**MORE PEOPLE BIKING
MORE OFTEN**

- Traffic Calming Initiatives – REPORT OF THE STANDING POLICY COMMITTEE ON INFRASTRUCTURE RENEWAL AND PUBLIC WORKS DATED FEBRUARY 4, 2020;
- Update to the Manual of Temporary Traffic Control on City Streets - **DDENDUM** –REPORT OF THE STANDING POLICY COMMITTEE ON INFRASTRUCTURE RENEWAL AND PUBLIC WORKS DATED APRIL 21, 2020
- Item #4: Report on Advertising Revenue

Manual on Temporary Traffic Control on city Streets

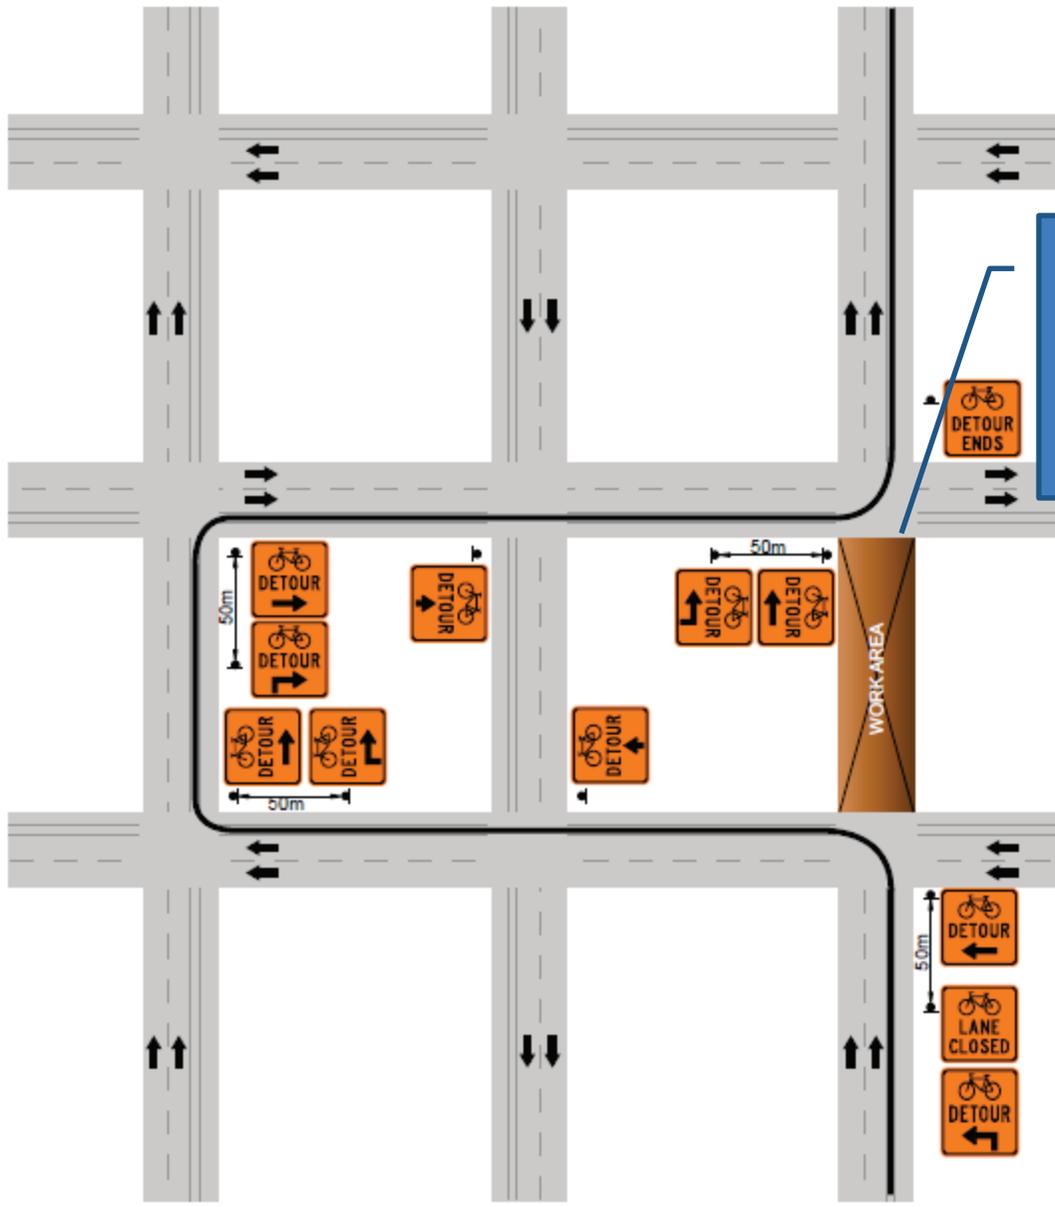
We're happy to see the recommendations to include detours for bike routes whenever road closures are required, but recommend that requirements for the provision of two-stage left turn queue boxes be included in the manual along with recommendations on detour signage. Two stage turn queues allow people on bike to navigate a left turn across multi-lane streets (as shown in the example diagram from the manual below) in a safe, two-step process rather than forcing the cyclist to merge across traffic lanes.

To improve safety and comfort, we'd like to see provision for two-stage turn queue's included in the design manual
